VISION PROFILE EXTRUSIONS

Sample Approval Form

Die #: 15766
Description: CWS 6" Wall Panel

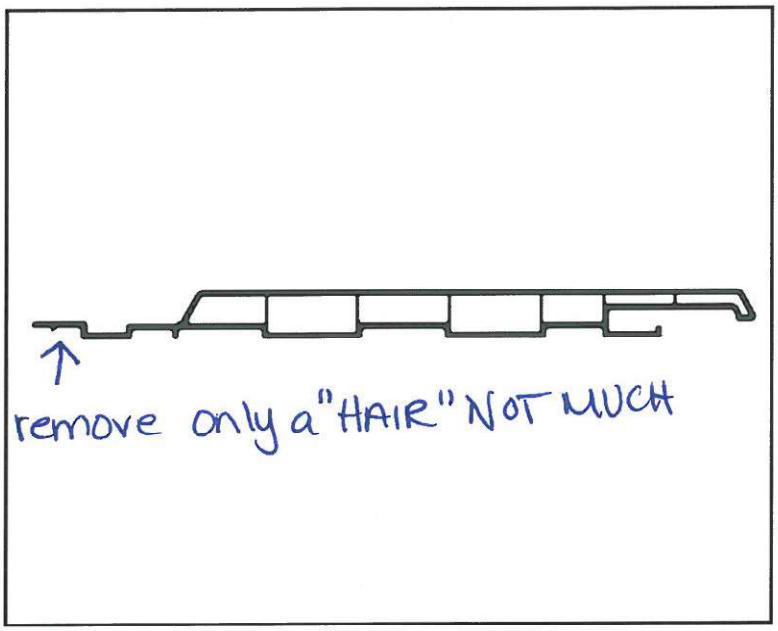
Comments: Excellent Quality.
Please take the line on back of nail fin down Only a "HAIR" You have a Westech panel there to compare But it is too much removed. So "not" as much as the Westech Sample
